## AGENDA

March 12, 2024  
7:00 p.m.

# WILDFLOWER DISPENSARY

RE: Site Plan Amendment Review for Wildflower Medical Marijuana/Adult Use Cannabis  
Dispensary

X-2	SHEET TITLE: <b>LANDSCAPE PLAN</b>	PROJECT TITLE: WILDFLOWERS DISPENSARY 9156 STATE ROUTE 14 STREETSBORO, OHIO	DATE: 2/1/24	REMARKS:
			DRAWN BY:

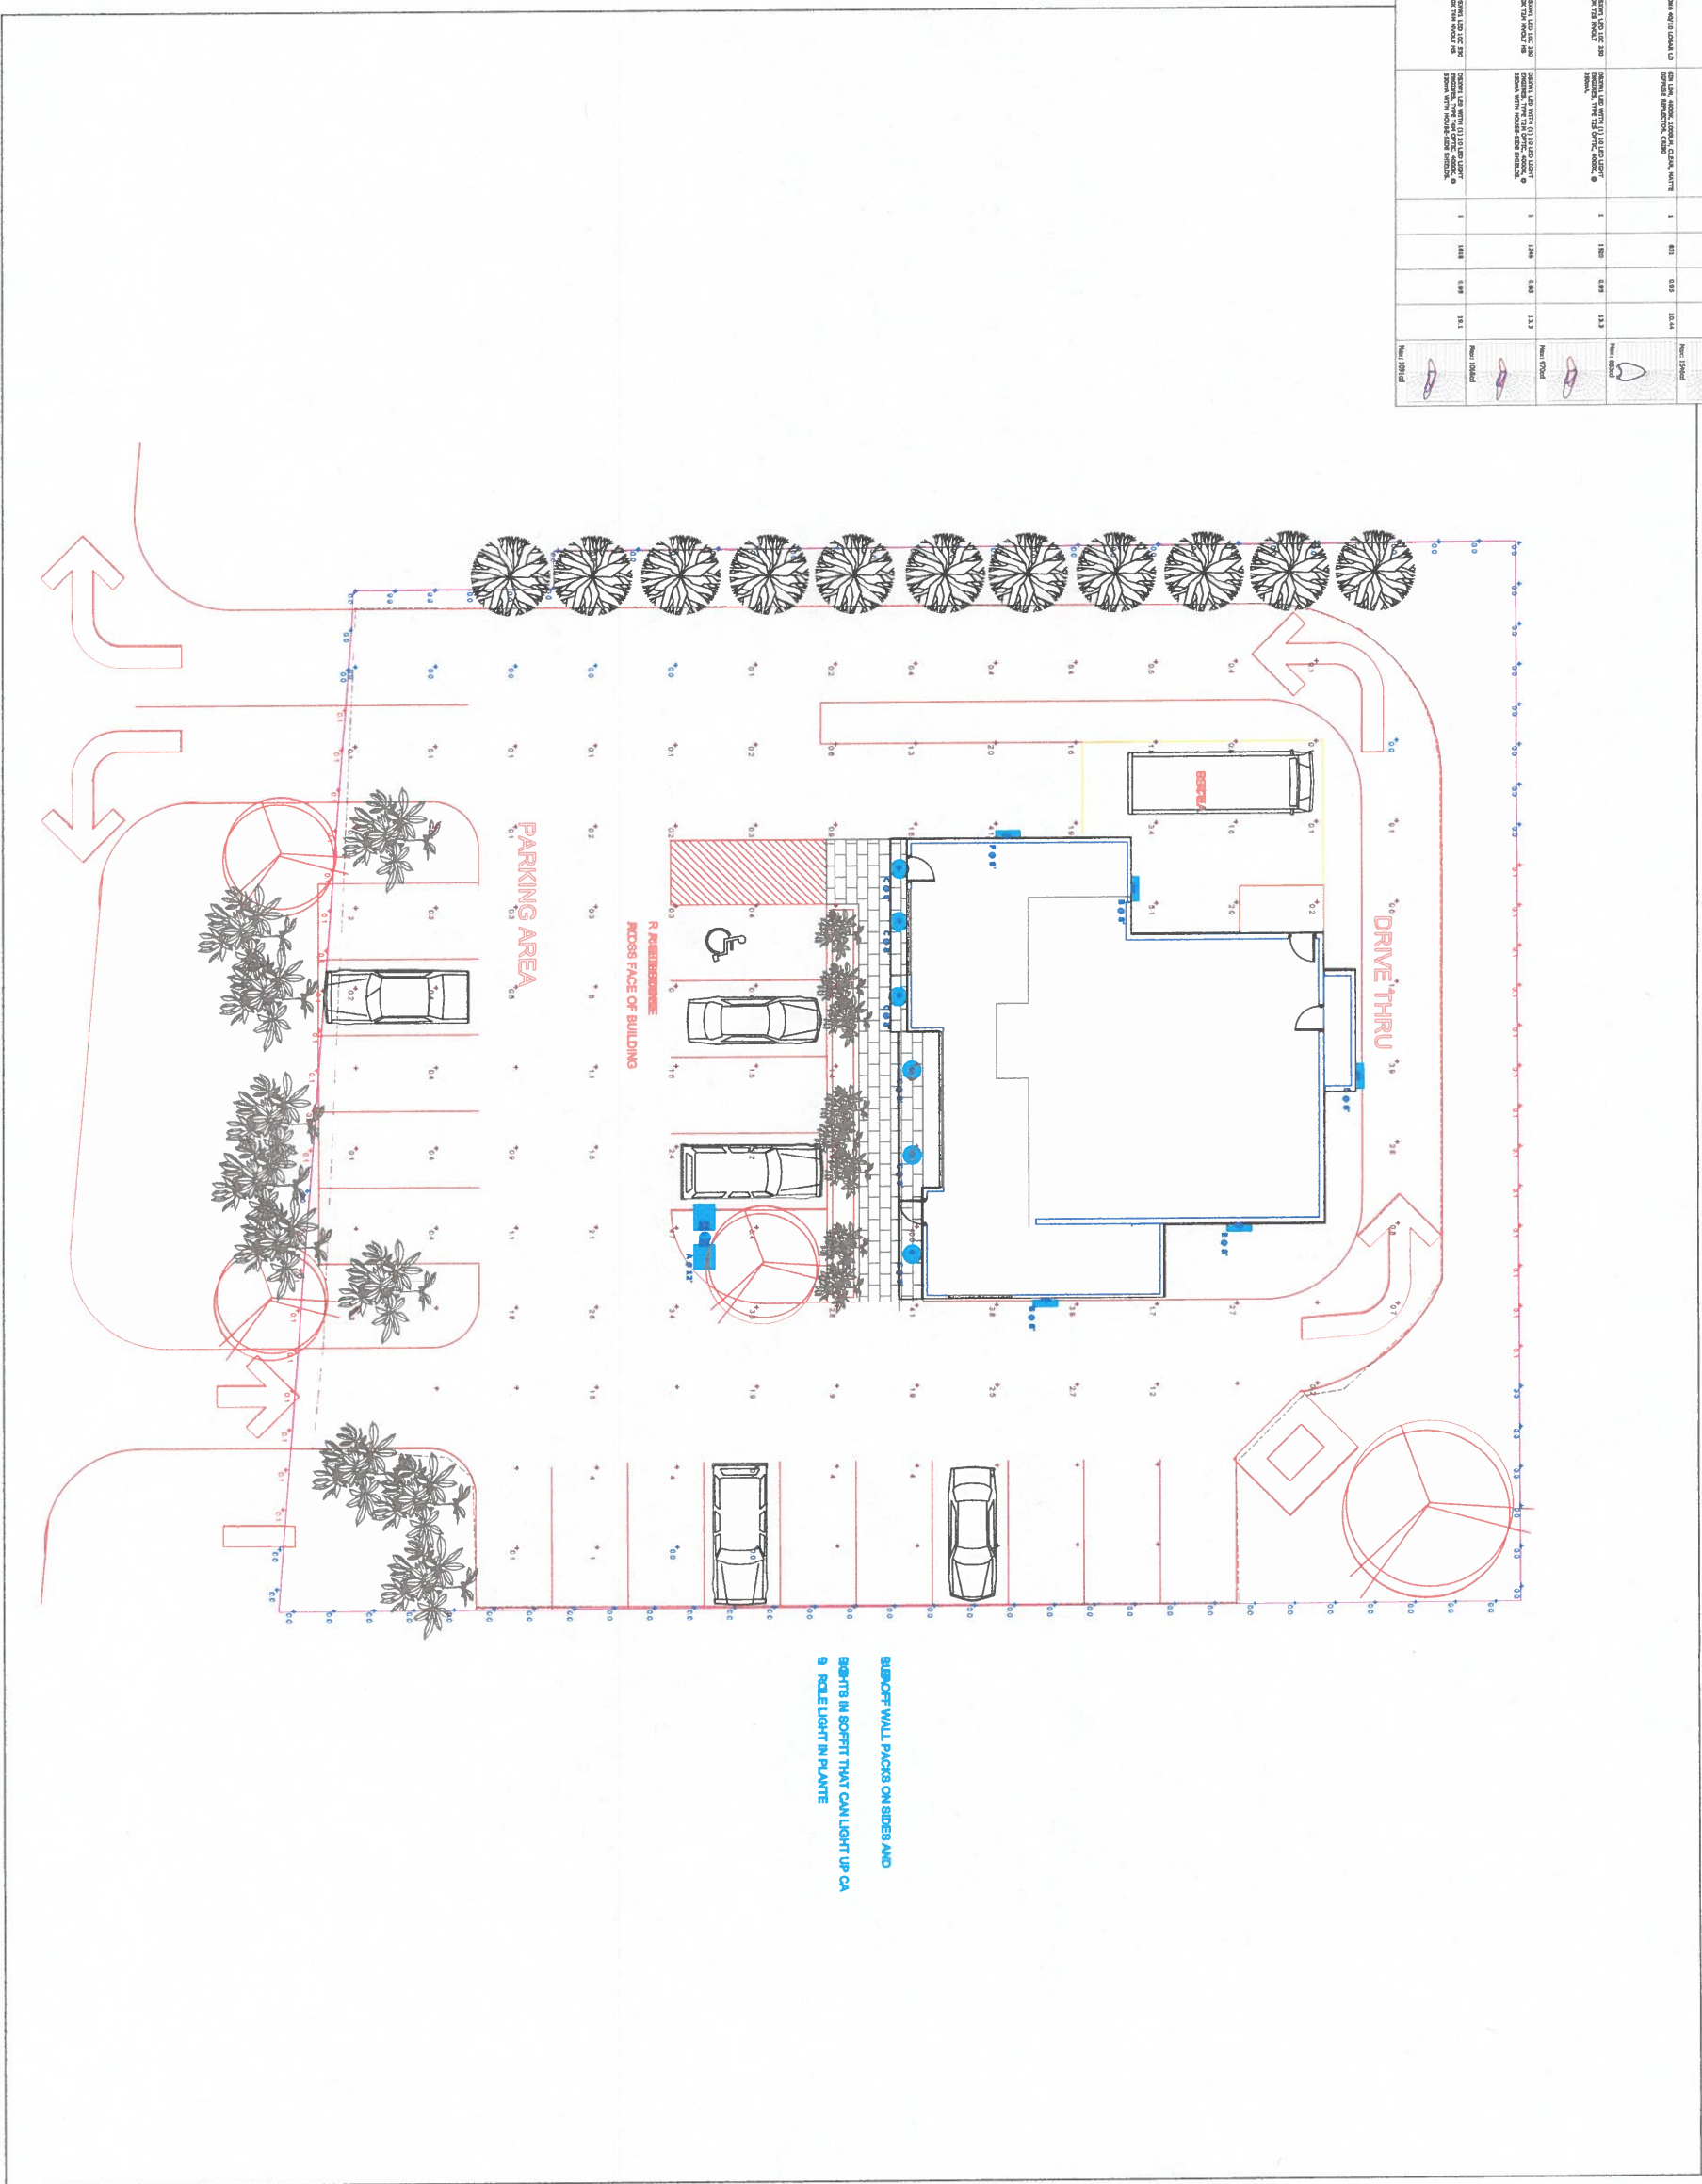
- a. Two notes should be added to the landscape plan that state: 1) That all dead or damaged plantings shall be replaced in perpetuity; 2) That any changes to the approved landscape plan are subject to review and approval of the Planning and Zoning Director.
- b. Landscaping around a monument sign is required to include at least a mix of coniferous plant material, providing year-round landscaping. The materials shown should be updated prior to formal application to the Planning Commission for sign approval.
- c. Landscape table should be included showing all proposed planting types, counts, and sizes at time of planting. Current plans also do not identify some trees shown on site.

- e. Applicant shall provide details of the security fence;
- f. Applicant shall include two notes on the landscape plan that state: 1) That all dead or damaged plantings shall be replaced in perpetuity; 2) That any changes to the approved landscape plan are subject to review and approval of the Planning and Zoning Director;

- g. Applicant shall provide a landscape table showing a complete proposal of planting types, counts, and sizes at time of planting.
- h. Applicant shall comply with Police comment letter dated 2/26/24;

**EXISTING CONDITIONS & DEMOLITION PLAN**

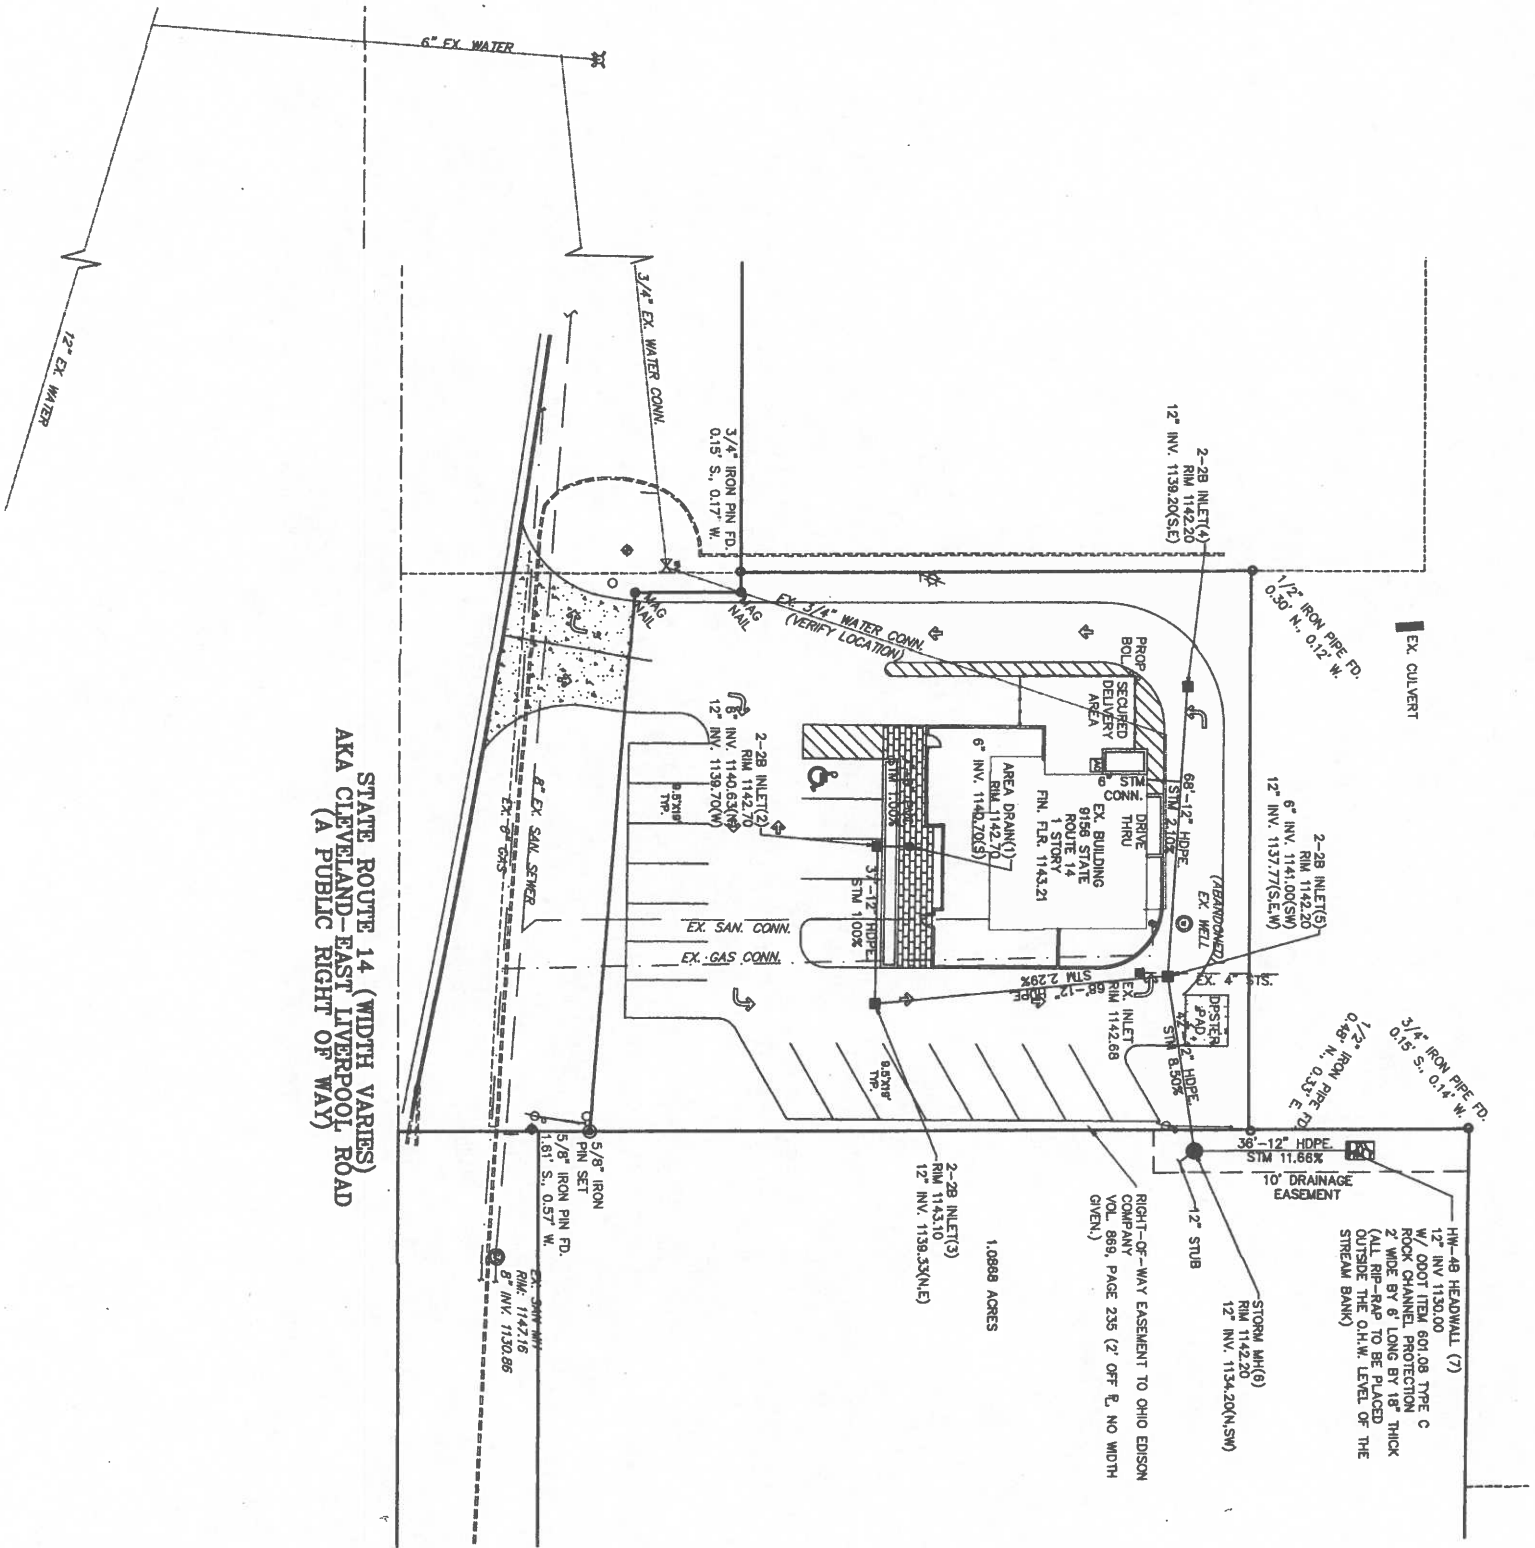
2. Show existing shrubs, stone wall and mailbox that are to be removed, or protected.
3. Is the existing curb to remain or be removed? Please denote the curb and identify its intention.
4. There is an existing gas valve in the easternmost driveway. Please identify it.

**UTILITY PLAN**

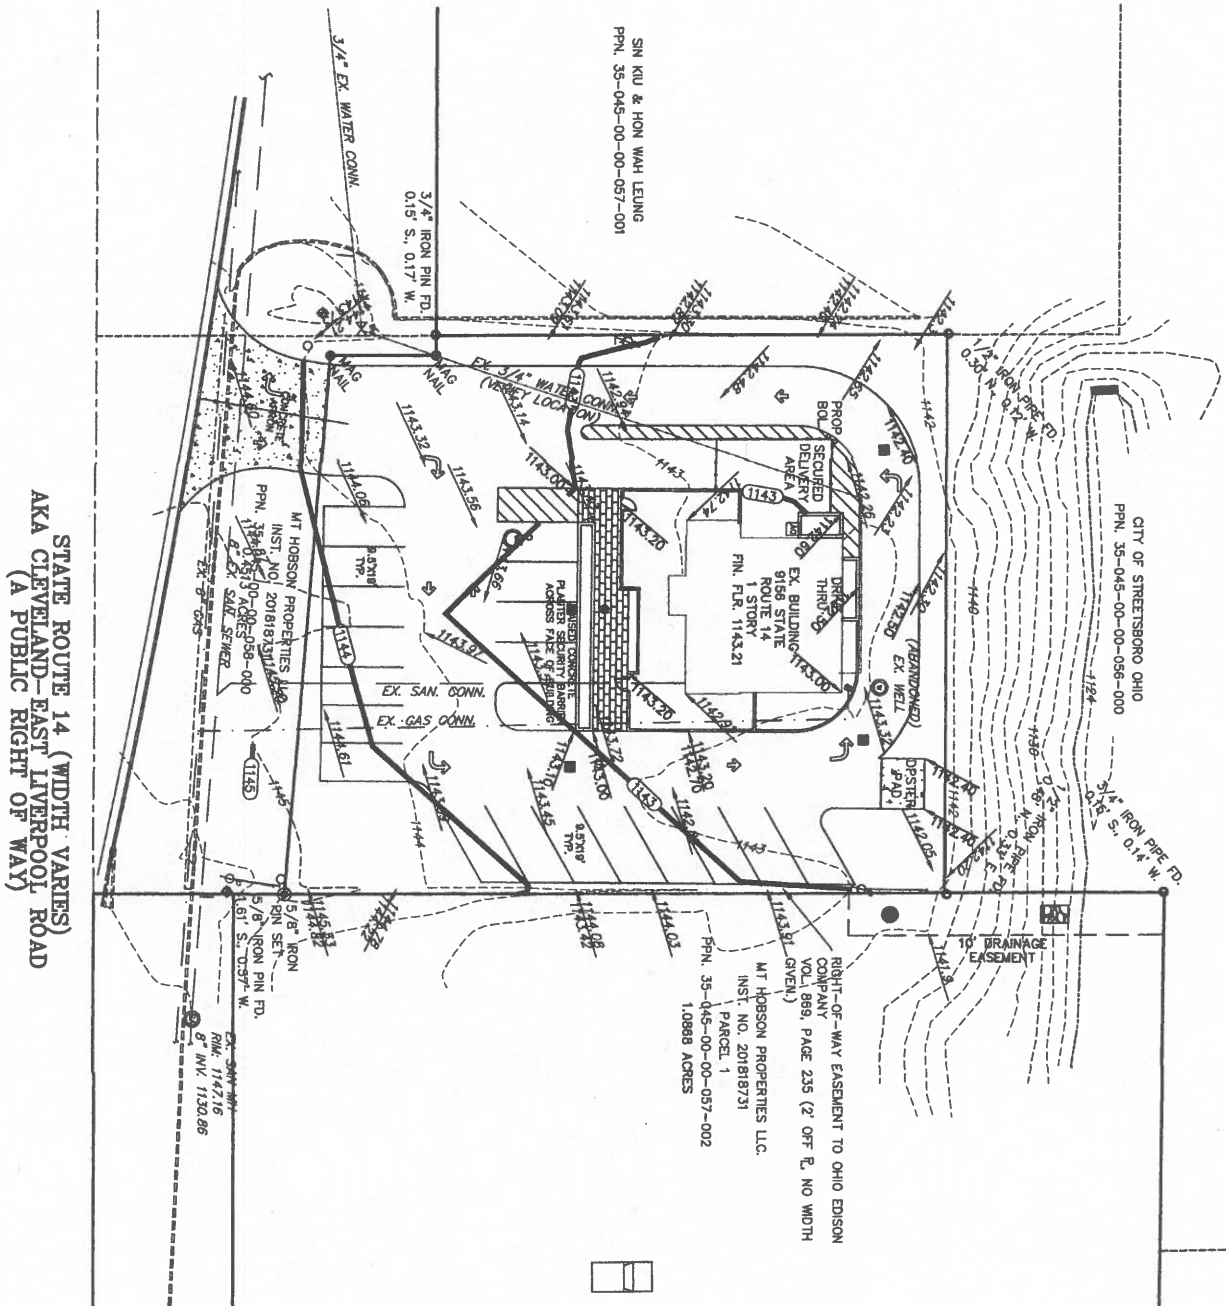
14. The existing inlet with rim elevation 1142.68 is shown to be removed on the demo plan. Show it on this sheet as to be removed as well.
15. Provide storm sewer capacity calculations and a drainage area map to each catch basin. Use a 10-year design storm and a 25-year HGL check storm.
16. Provide minimum vertical clearance between proposed storm and existing sanitary and gas.

**#1- Required Revision:** Utility Plan- The drawing shows an existing  $\frac{3}{4}$ " water connection after the water shut off valve. This property is currently not connected to City Water. A service line will need to be installed from the water shut off into the building. All tap in fees and other related fees will need to be paid. If you require a larger size line than a  $\frac{3}{4}$ ", the existing tap will need to be abandoned and a new tap installed at the owner's expense.

**#2- Required Revision:** Utility Plan- Shows and existing abandoned well. You must show proof that the well was properly sealed or the well will need to be properly sealed as part of the project and documentation submitted to the Water Department.

**GRADING PLAN**

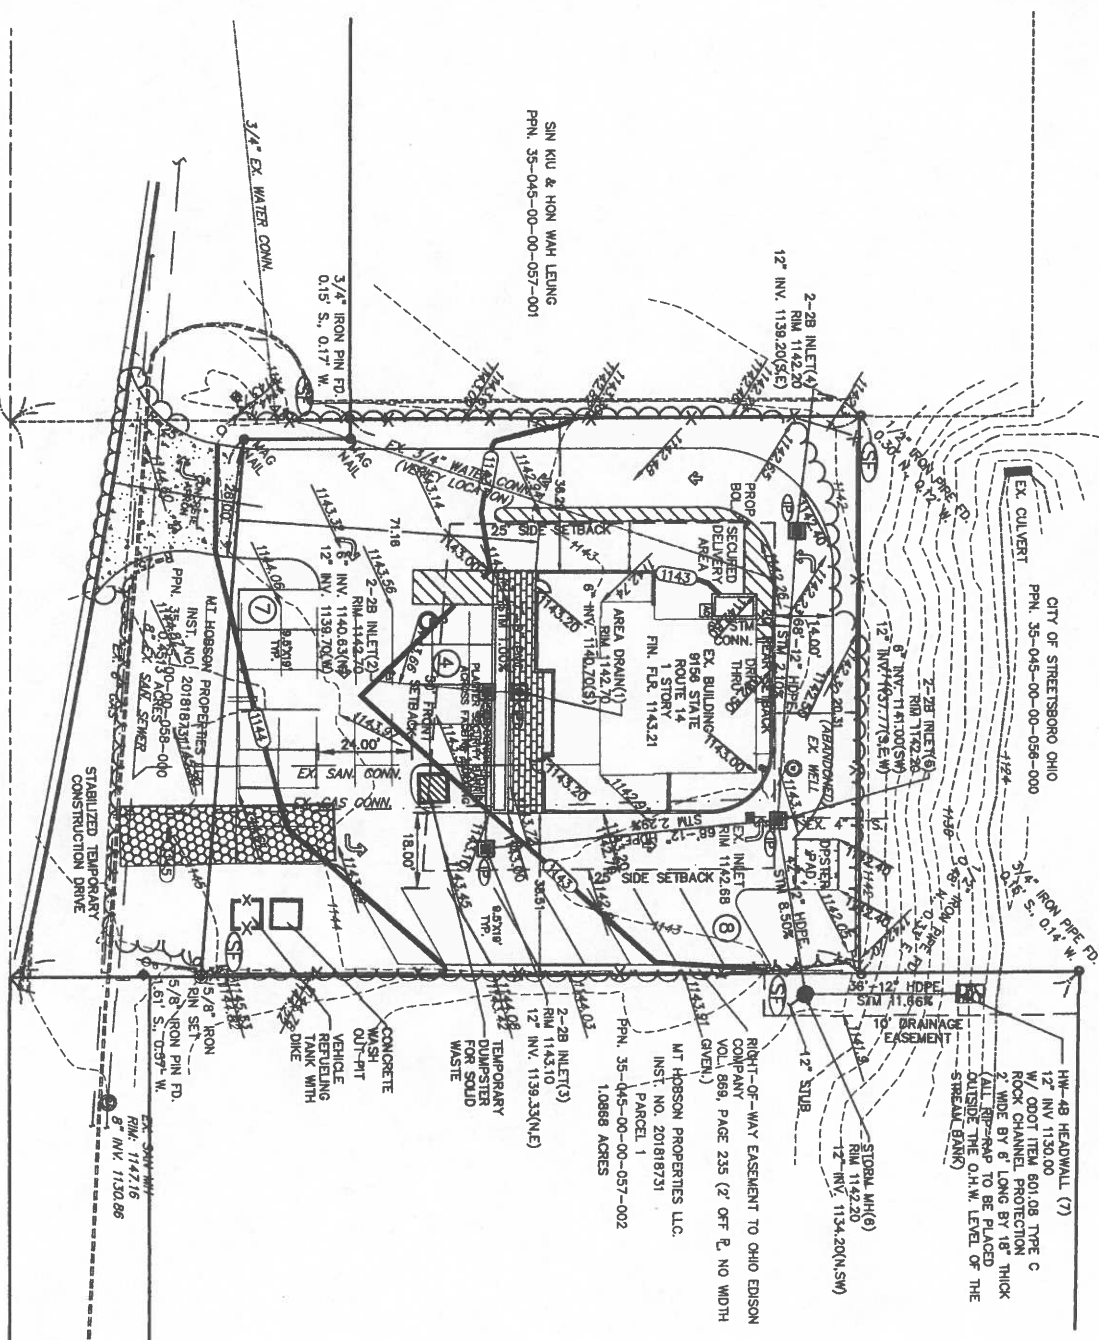
17. More spot elevations are needed to determine if slopes are compliant with ADA requirements.
18. Show elevations of the top and bottom of the proposed concrete planter.
19. If there is curbing around the perimeter of the site, show elevations of top of curb and bottom of curb at various points.
